**PSE&G** Public Service  
Electric and Gas  
Company

August 20, 1984

HOPE CREEK GENERATING STATION  
DOCKET NO. 50-354  
DRAFT SAFETY EVALUATION REPORT  
OPEN ITEM STATUS

Attachment 1 is a current list which provides a status of the open items identified in Section 1.7 of the Draft Safety Evaluation Report (SER). Items identified as "complete" are those for which PSE&G has provided responses and no confirmation of status has been received from the staff. We will consider these items closed unless notified otherwise. In order to permit timely resolution of items identified as "complete" which may not be resolved to the staff's satisfaction, please provide a specific description of the issue which remains to be resolved.

FIGURE 210.21-13

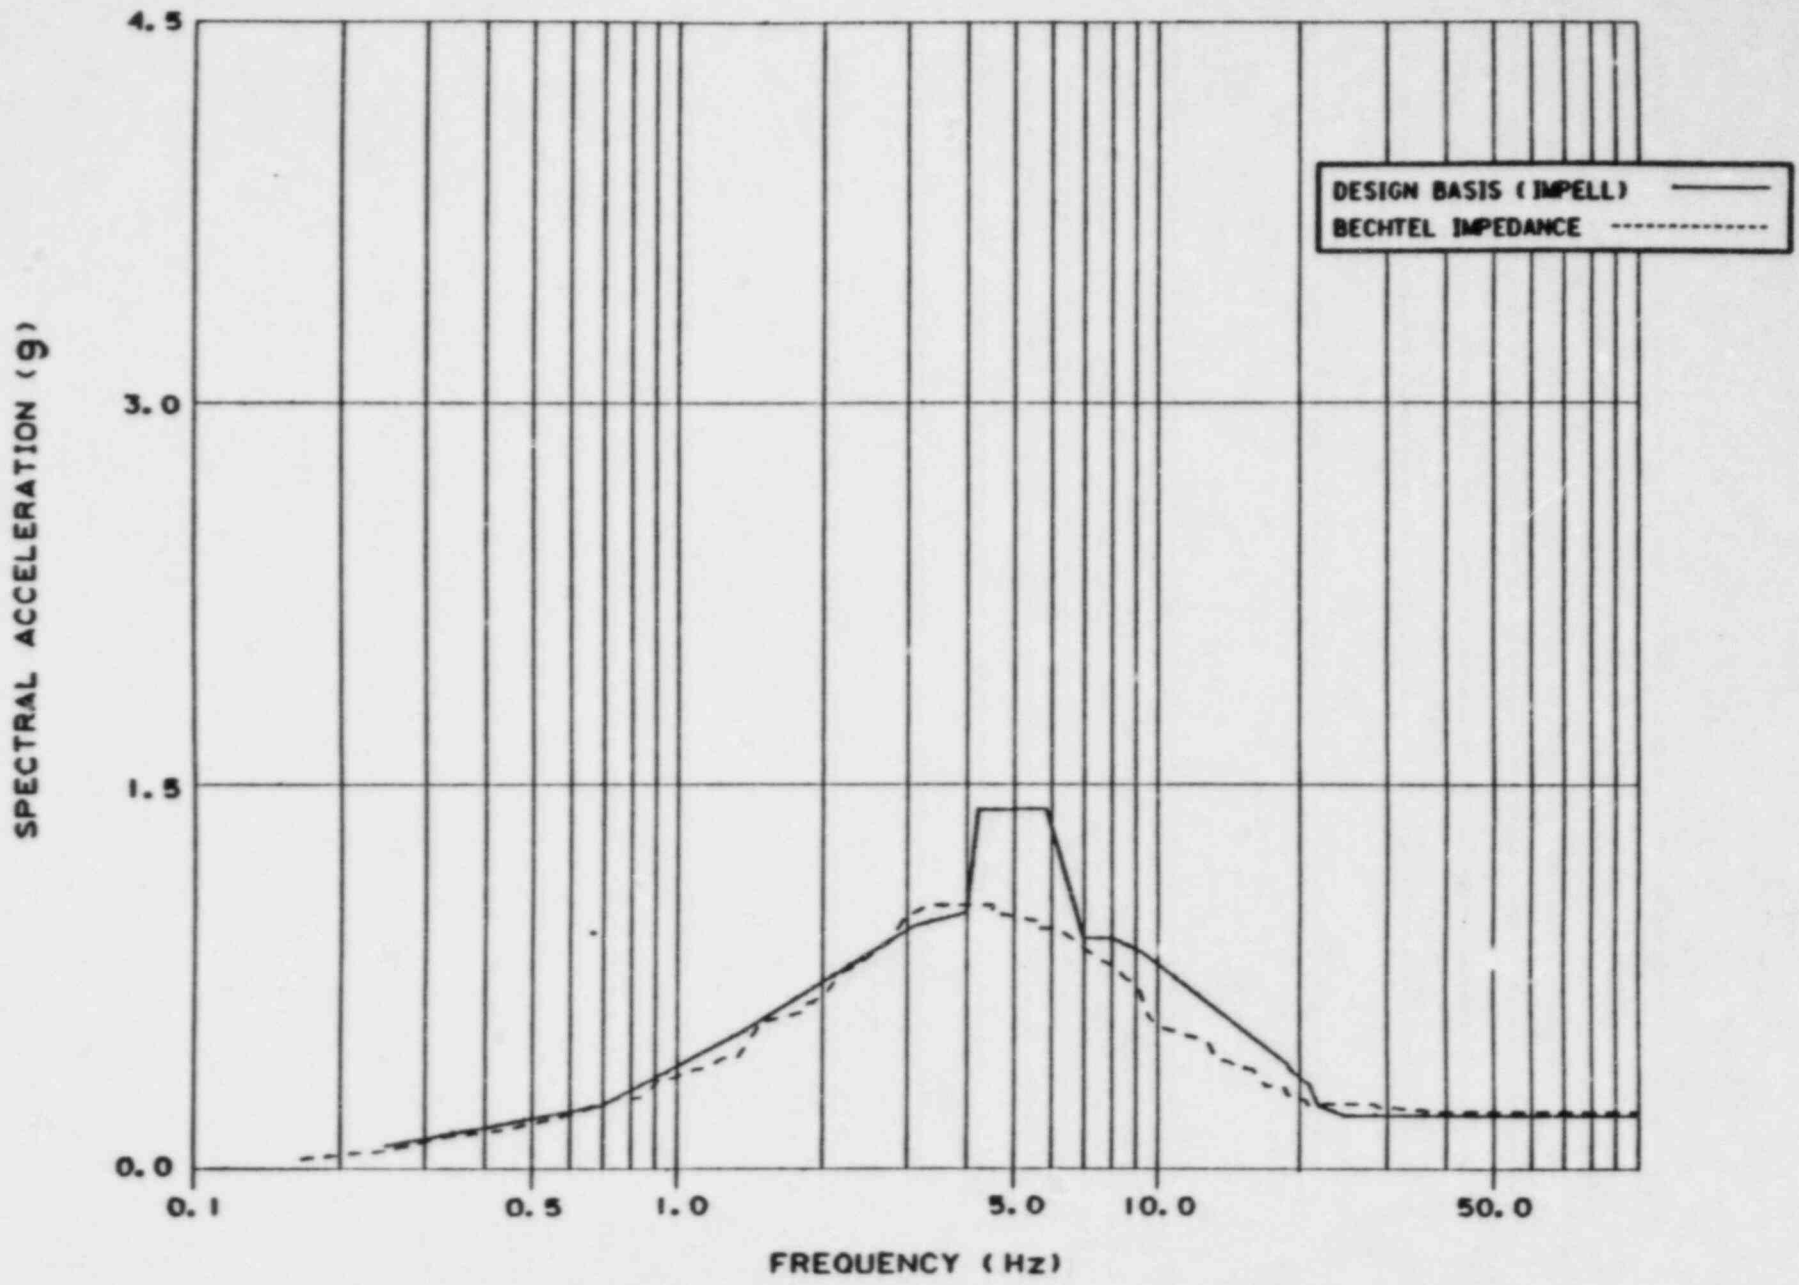
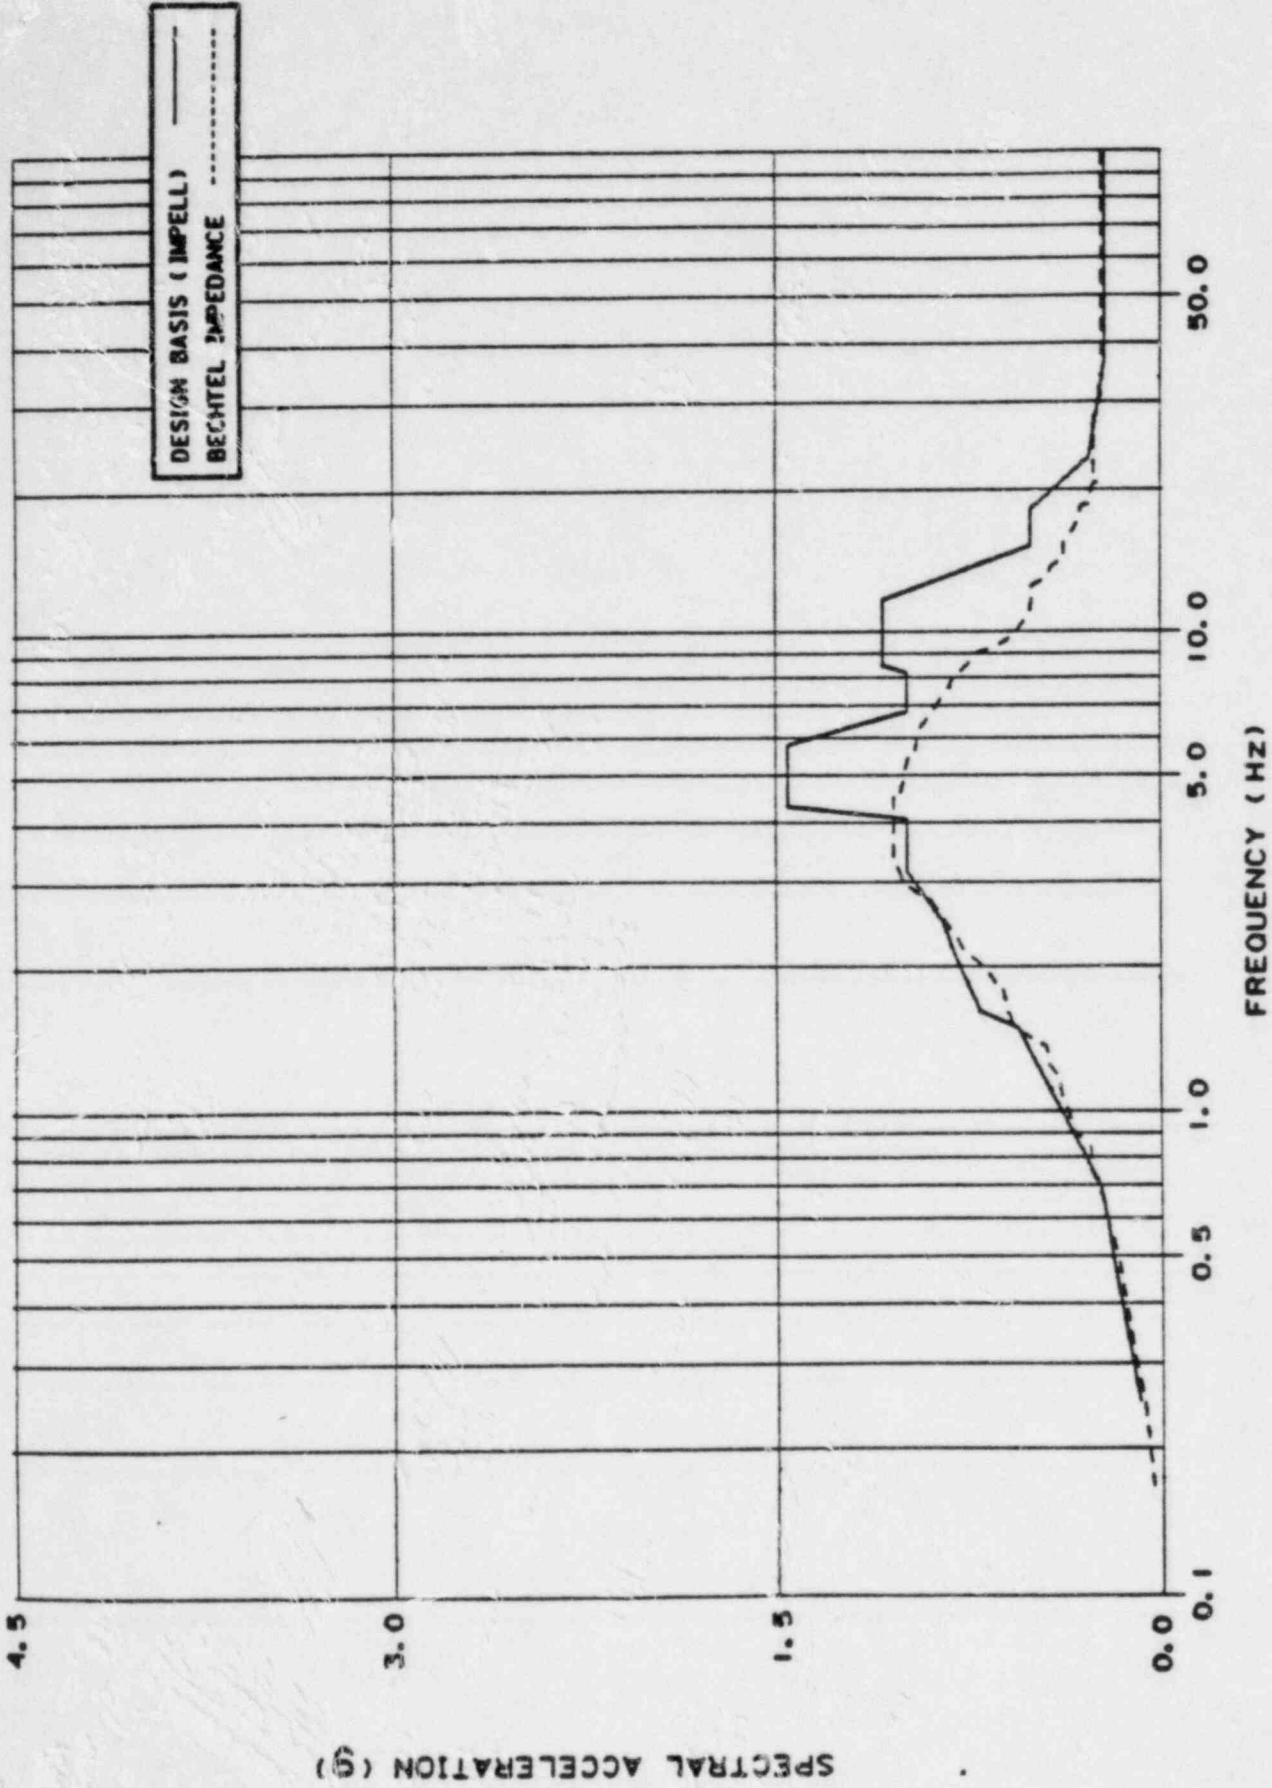
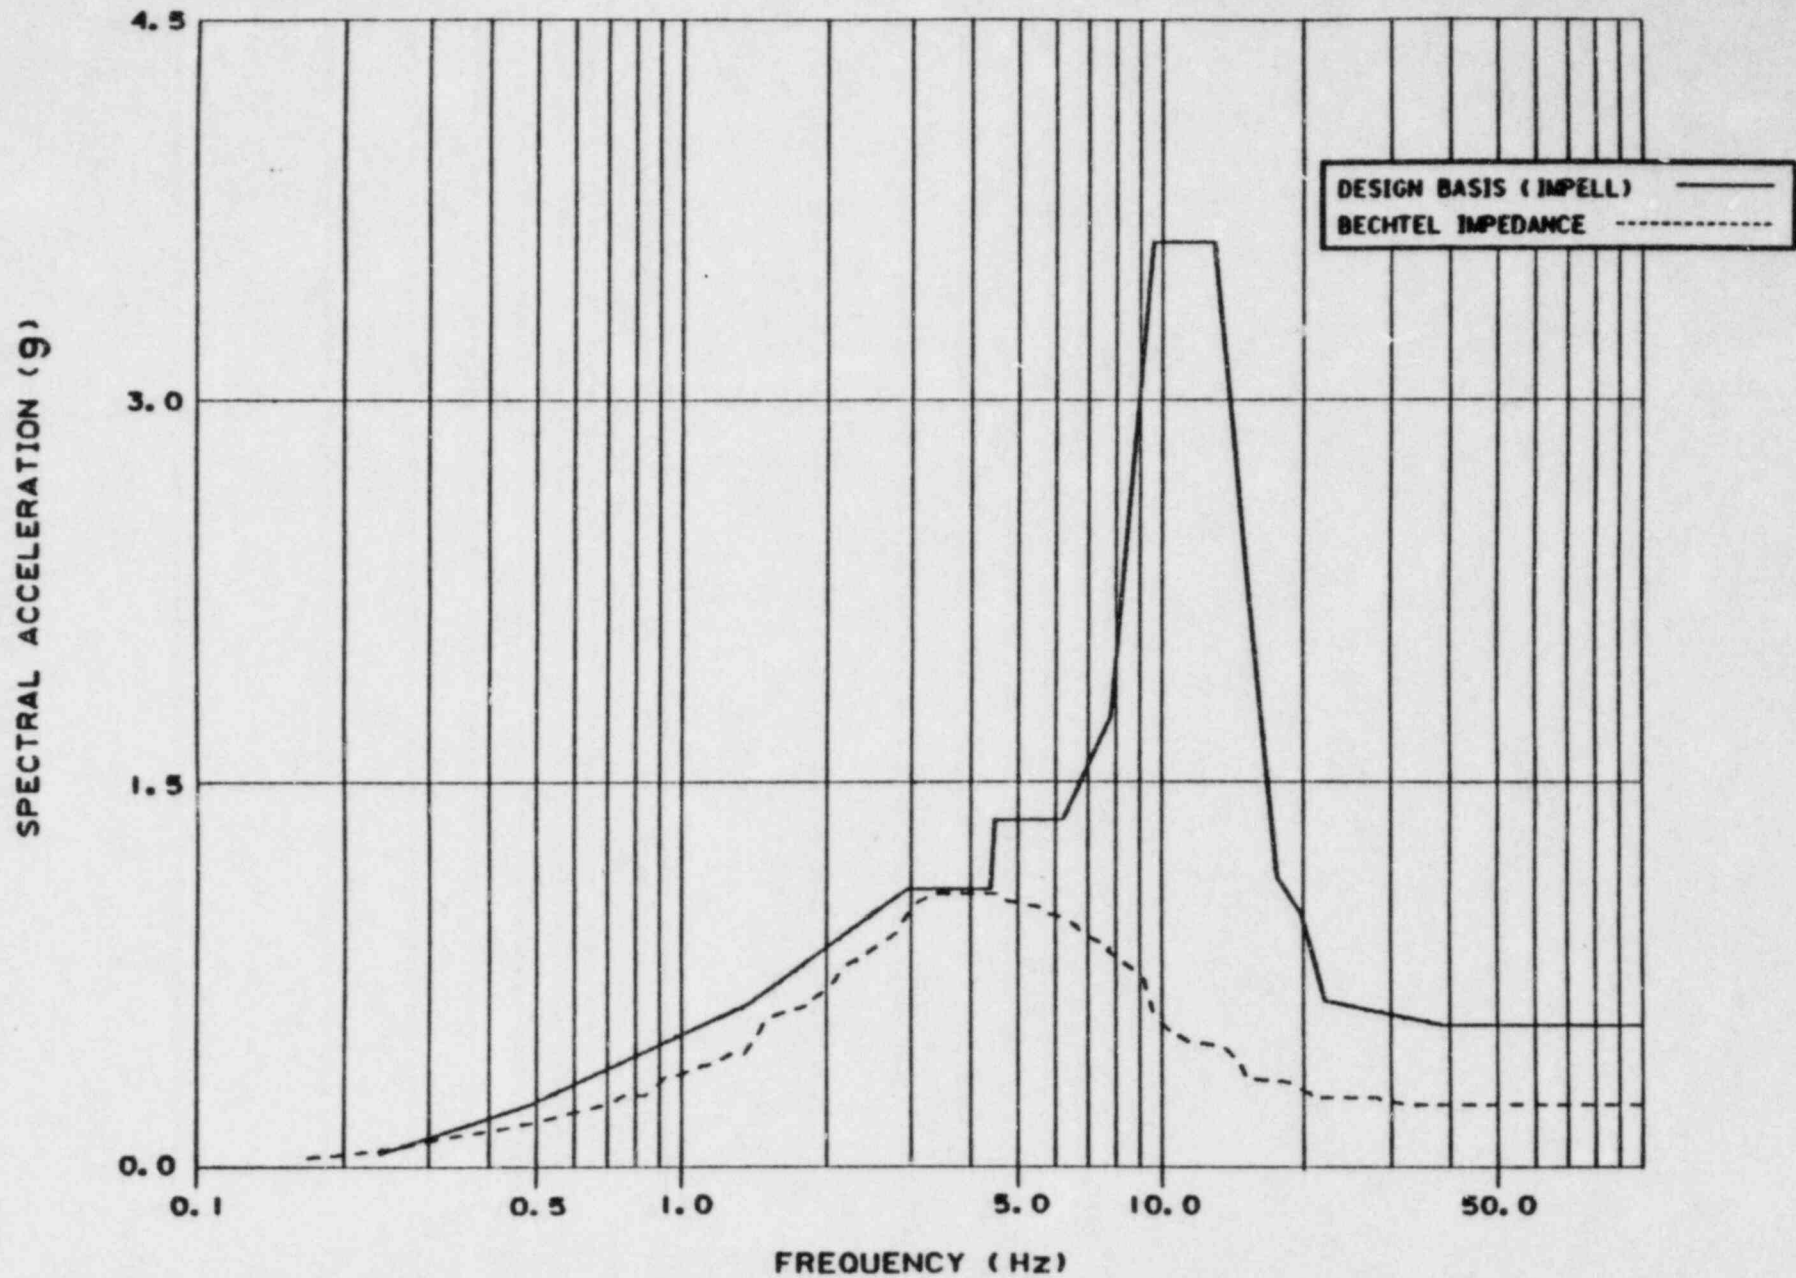
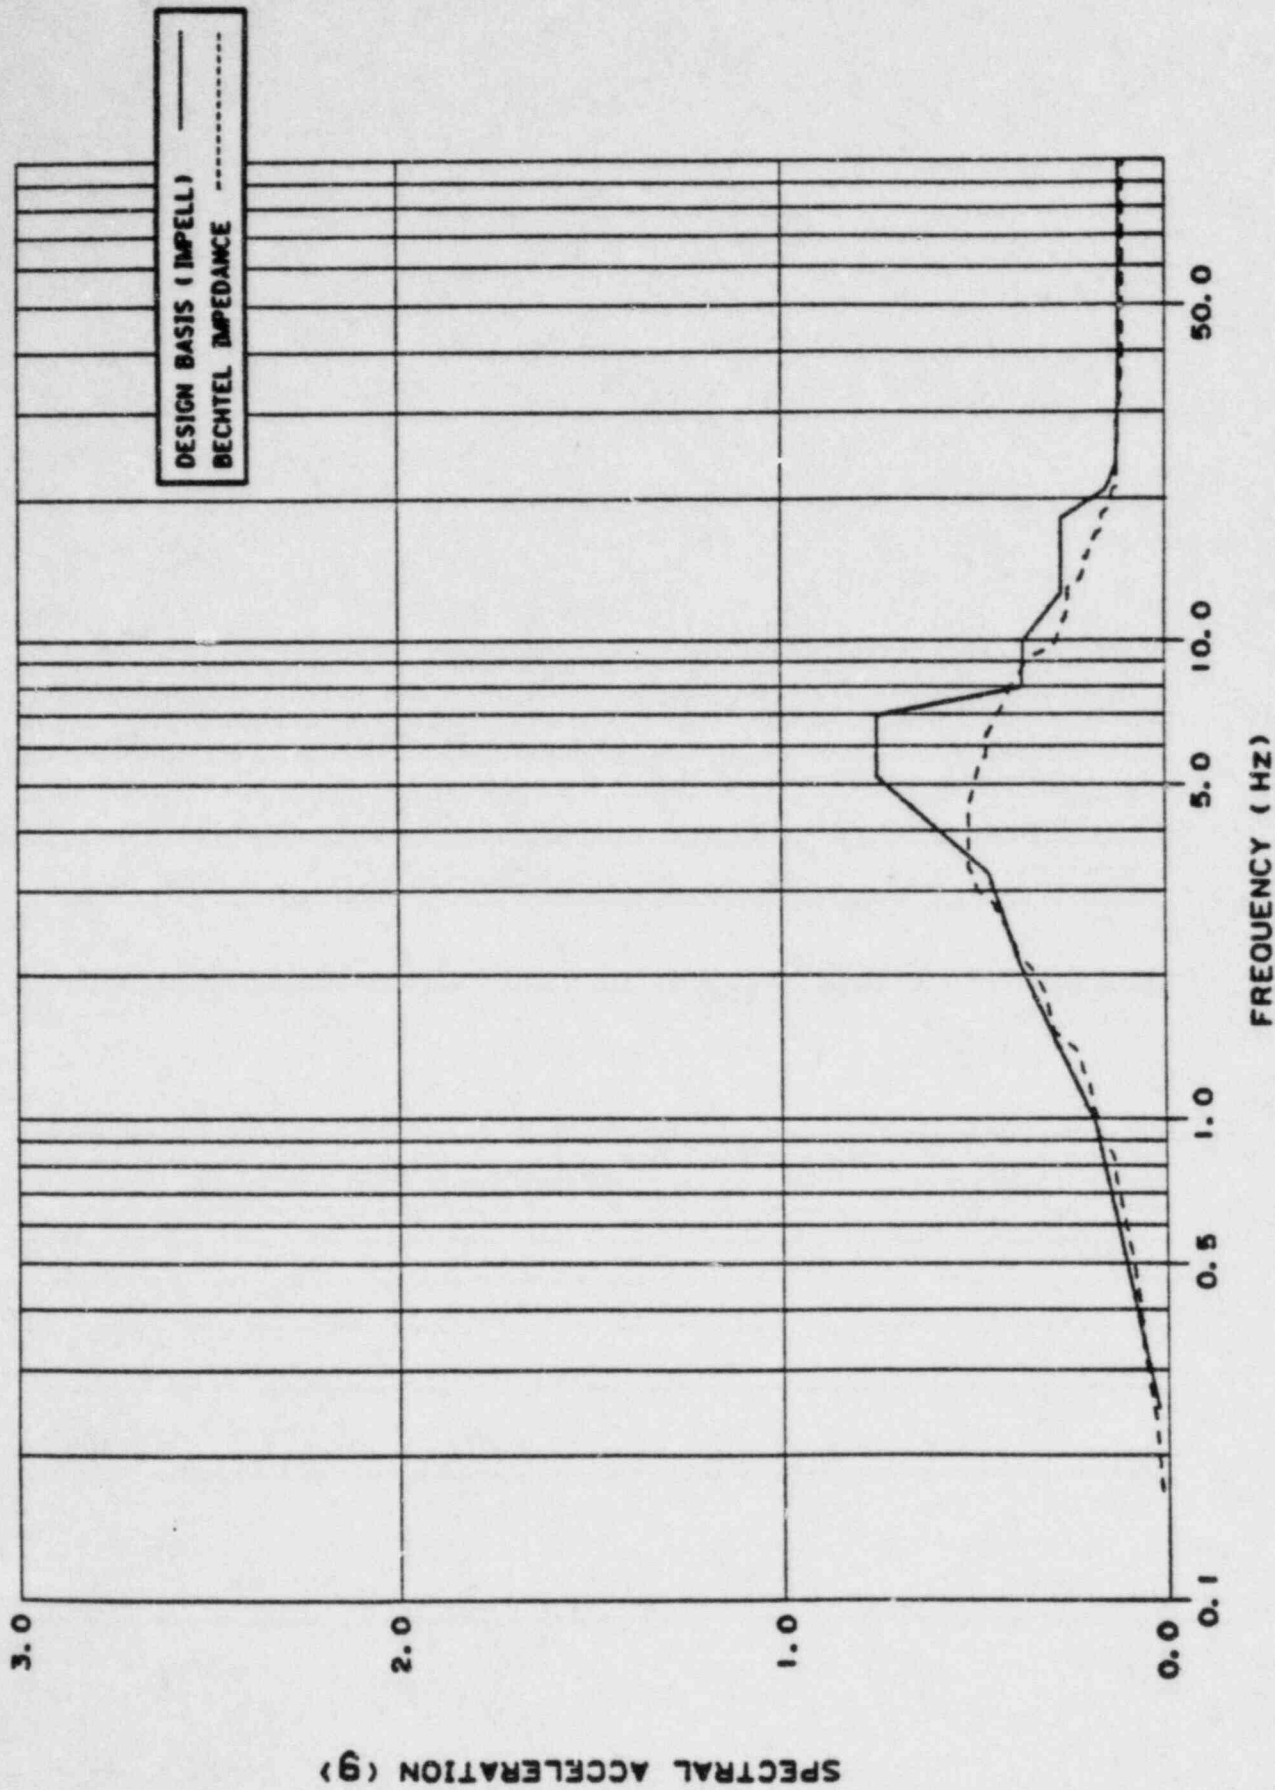
Figures 220.21-1 through 220.21-54 show a comparison of the 2 percent damping response spectra obtained from the design basis finite element and the impedance analyses for the reactor building, auxiliary building and the service water intake structure (SWIS).

¶ For the reactor and auxiliary buildings, the peak spectral accelerations obtained from the impedance analysis are generally lower than those obtained from the design basis analysis. However, the impedance analysis response spectra are not completely enveloped by those obtained from the design basis analysis, especially in the frequency range from 1.0 to 3.5 Hz. Also, there are some local exceedances in the higher frequency range, as shown in Figures 220.21-1 through 220.21-36. ¶ For the SWIS (Figures 220.21-37 through 220.21-54), the impedance analysis response spectra are generally enveloped by those obtained from the design basis analysis at elevation 114.0 feet. For other elevations, the impedance analysis spectral accelerations exceed the design basis spectral accelerations in some frequency ranges. These ranges vary approximately between 1.5 and 10.0 Hz.

In all cases, the items reviewed during these sampling studies can accommodate the loads resulting from the impedance analysis. Therefore, the impedance analysis results have no impact on the plant design.
